MEMO:—

PROPOSED BUILDING

ON PLOT NO 7 SHEET NO F. 3

PREEDY QUARTER

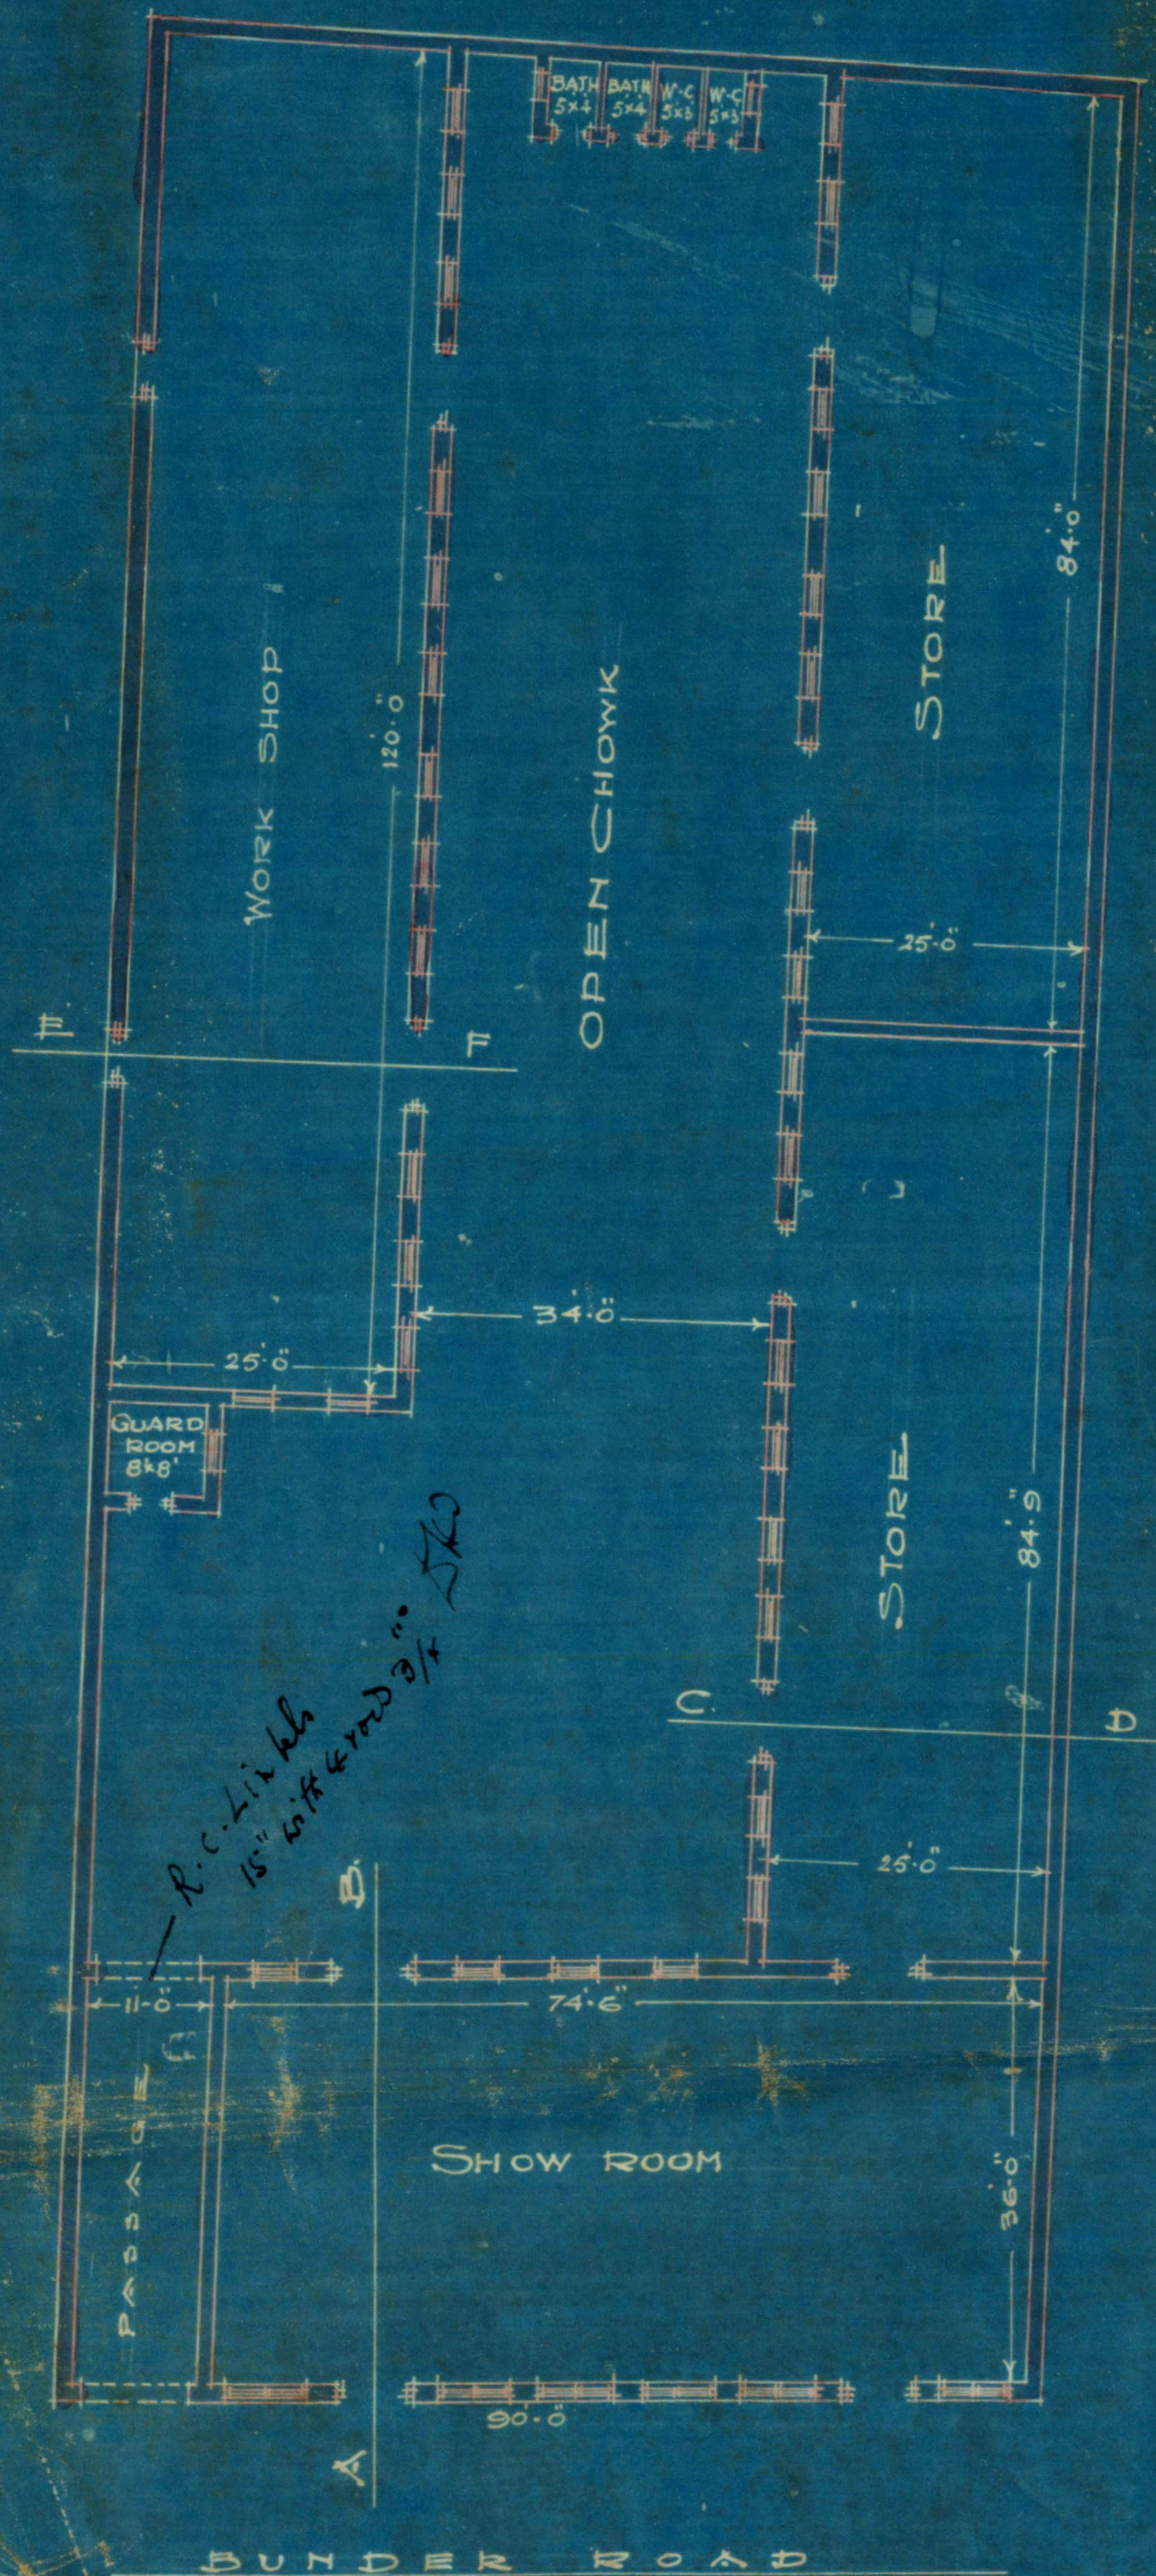
- 9
- (1) R.S. Beam for a span of 36' is insufficient. It should be at least $24'' \times 7\frac{1}{2}''$ to guard against excessive deflection.
 - (2) Size of doors and windows with nature and size of lintels ^{as well as over the canopy at the east} over them, to be given.
 - (3) ~~Nature and size of partition wall in store at the rear.~~
 - (4) Nature of roofing over workshop, nature and size of partition in store at the rear.
 - (5) Section of bath and w.c. to be given.
 - (6) Provisions of adequate size to be provided below R.S. beams.
 - (7) The proposed spacing of half trusses used for workshop and store to be given. It is desirable that a standard half truss is used instead of the arrangement shown at present.
(For trusses spaced 8' c to c.)

$$\begin{aligned} P_r &= 4'' \times 7'' \\ J.B. &= 4'' \times 4'' \\ S.d.m.b. &= 4'' \times 3'' \\ C.R. &= 4'' \times 3'' \text{ at } 1\frac{1}{2}' \text{ c to c.} \end{aligned}$$
 - (8) It is desirable to provide for roof-ventilation in workshop.

SECTION ON C.D. & E.F.

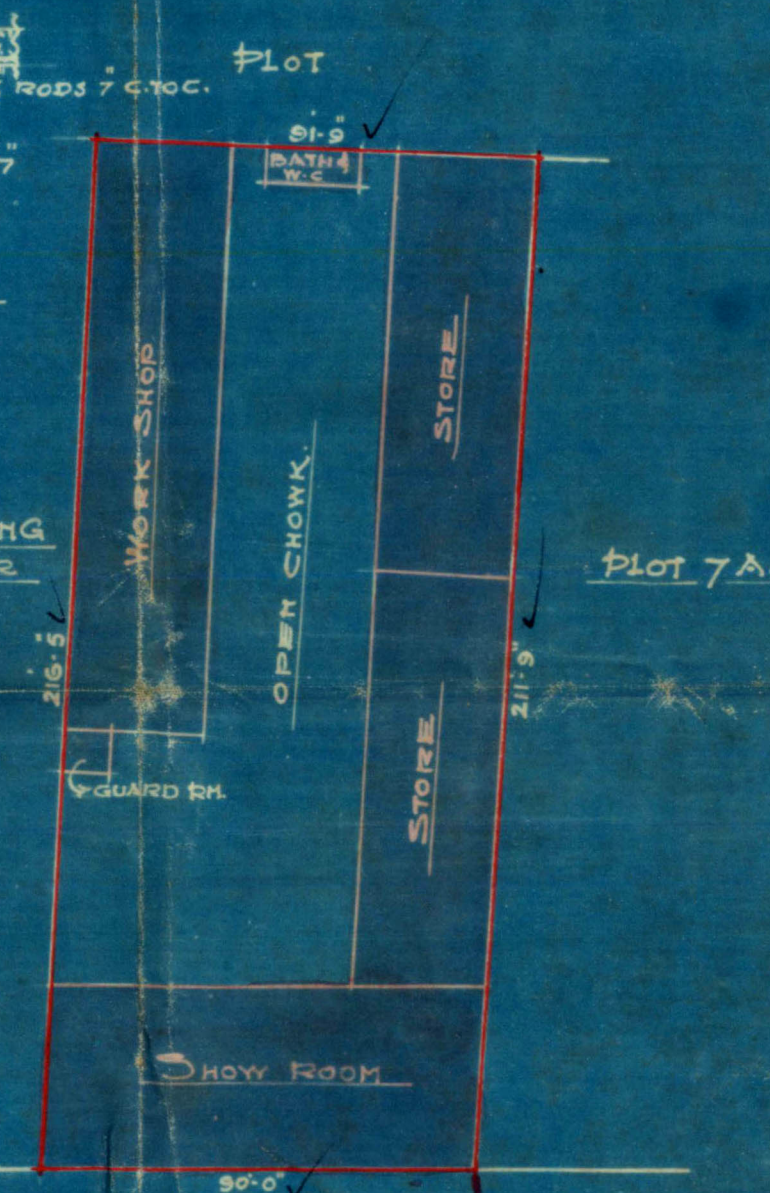
- (1) The size of R.S. Beams is not enough unless the architect undertakes to box the beam with Cement Concrete.
- (2) Size of doors and windows with nature and size of lintels over them as well as over the passage at the east to be given.
- (3) Nature of roofing over workshop and nature and size of partition wall in store at the rear to be given.
- (4) Section of bath and W.C. to be given.
- (5) Bed stones of adequate size to be provided below R.S. Beams.
- (6) The proposed spacing of half-trusses used for workshop and store to be given. It is desirable that a standard half-truss is used instead of the arrangement shown on plan.
- (7) (8) It is also desirable to provide for roof-ventilation in workshop.
- (8) (9) Side-dimensions of site to be checked.

The architect has removed objections nos. 2, 3, 6 and 8.

Re-objection no. 1 the architect checked with me that the size was alright.

no. 4. Bath & W.C. Section may not be shown.

no. 5. He says he will surely provide a bed stone when he is putting a beam. or else he might make other arrangements, suit the bedding of beams. He may not show it on plan

no. 7. He has got ample nos. of windows for cook shop, I do should not think extra ventilations quite necessary.
